Date: August 5, 2025
To: FILE: ECSI #6556
Through: Amanda Wozab and Wesley Thomas
From: Brian Church
Northwest Region
Subject: Gresham Memorial Chapel, ECSI #6556; Staff Memorandum in support of a Conditional No Further Action determination

This document presents the basis for the Oregon Department of Environmental Quality's (DEQ's) recommended Conditional No Further Action (CNFA) determination for the Gresham Memorial Chapel facility, in Gresham, OR. As discussed in this memorandum, contaminant concentrations in soil and groundwater exceed DEQ's risk-based concentrations, however the DEQ believes that, based on currently available information, institutional controls are sufficient to mitigate risk at the site. The contents of this memo are largely based on initial reporting by DEQ (2023a), later Site Investigation and the *Independent Cleanup Program Report* (i.e., ICP Final Report) (Environmental Works 2024; 2025), and revisions to the ICP Final Report based on comments provided by DEQ (2025a).

FIGURE 3: SITE PLAN MAP WITH SOIL, SWI SOIL, GROUNDWATER, AND SOIL VAPOR SAMPLE LOCATIONS

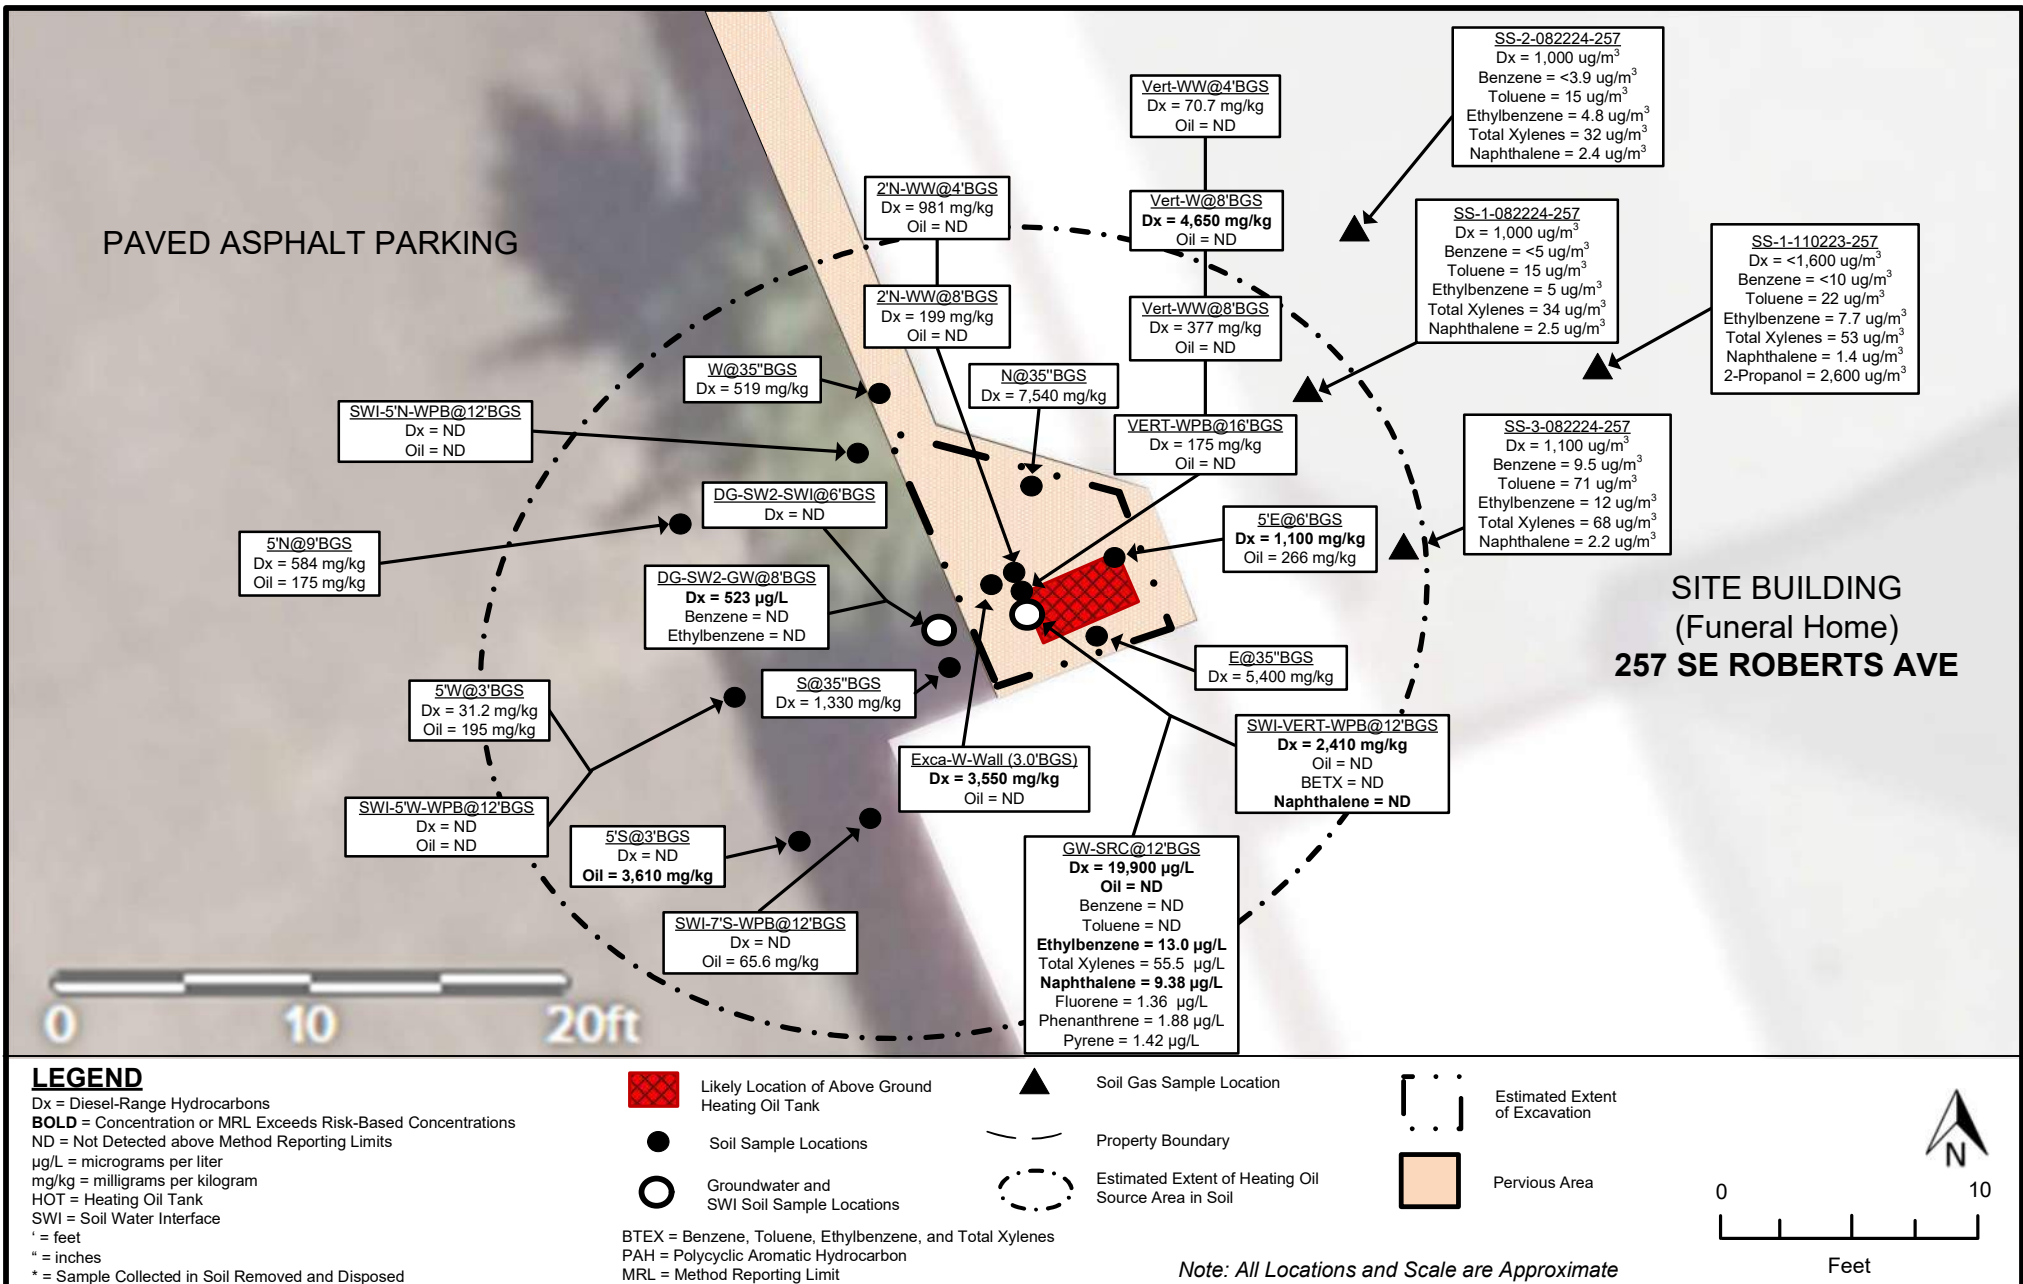
Soil, groundwater, and sub-slab soil vapor samples were collected at the site in 2023 to 2024. The LOF is shown in Attachment 1 Figure 2. Dashed black polygons encircle the area of concern. Attachment 1 Figure 3 shows samples within a smaller radius around the area of concern. Both figures present the results of sampling.² Methods and results are summarized in Section 3.

Four locations within the Gresham Memorial Chapel foundation footprint were sampled for sub-slab soil vapor at DEQ's request. These are shown most clearly in Attachment 1 Figure 2. Three samples were collected on August 22, 2024 during a period of declining barometric pressure (as reported by Weather Underground at Portland International Airport). Attachment 3 shows the barometric pressure pattern at the time of sampling.

Attachment 1 Figures 1 and 2 provide rough estimates of the areas of impacted soil and groundwater within the LOF. While the method used by Environmental Works (2025) to draw the impacted area estimate is unclear, we believe the estimate to be reasonable given the available data.

FIGURE 4:
DEQ RBDM CONCEPTUAL SITE MODEL (CSM)
ABOVEGROUND STORAGE TANK (AST) LEAK –
RISK-BASED EVALUATION REPORT
257 SE ROBERTS AVE, GRESHAM, OR 97080
ECSI NO.: 6556

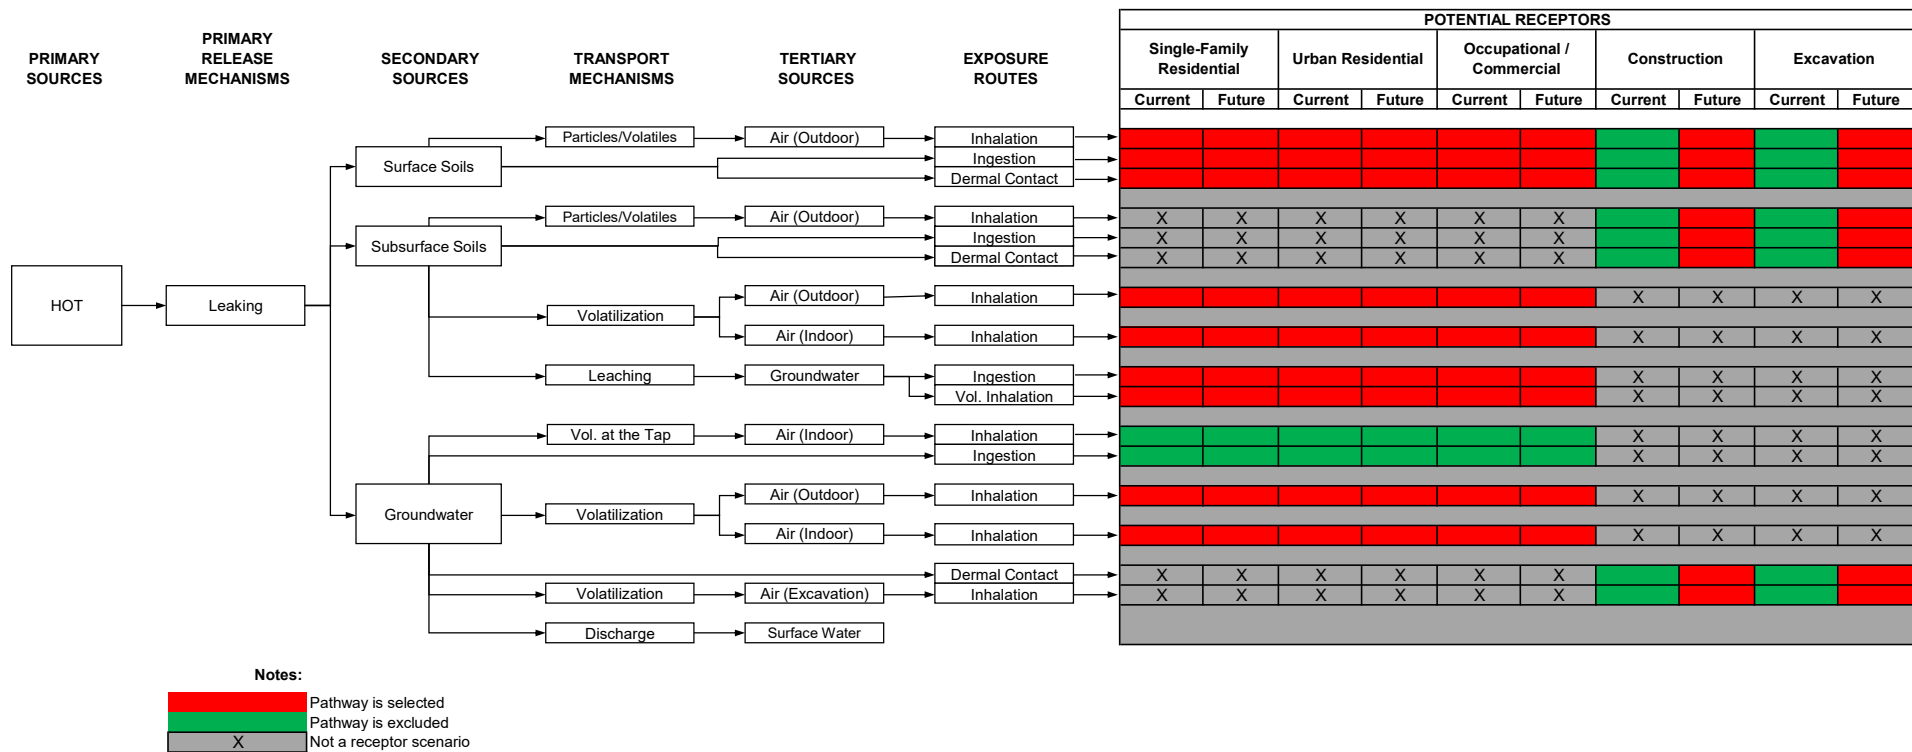
The conceptual site model (CSM) for Gresham Memorial Chapel is presented in Attachment 1 Figure 4. In general, all default exposure scenarios and receptor pathways are complete at the facility except for groundwater inhalation/ingestion for residential and occupational receptors. DEQ considers these pathways incomplete since municipal tap water is available and already provided to the site. Construction worker and excavation worker receptors may, however, be exposed to contaminated groundwater while working. Applicable human health risk-based concentrations (RBCs) were considered for complete pathways.⁶ Chemicals of interest are limited to petroleum-related contaminants associated with the release(s) of diesel from the AST.

⁶ Environmental Works (2025) also considered urban residential receptors their CSM (Attachment 1 Figure 4), which DEQ no longer uses as a default consideration. They also separated current and future uses and, in the case of soil exposures, however DEQ does not generally make this distinction when managing a site; current and likely future uses are both protected.
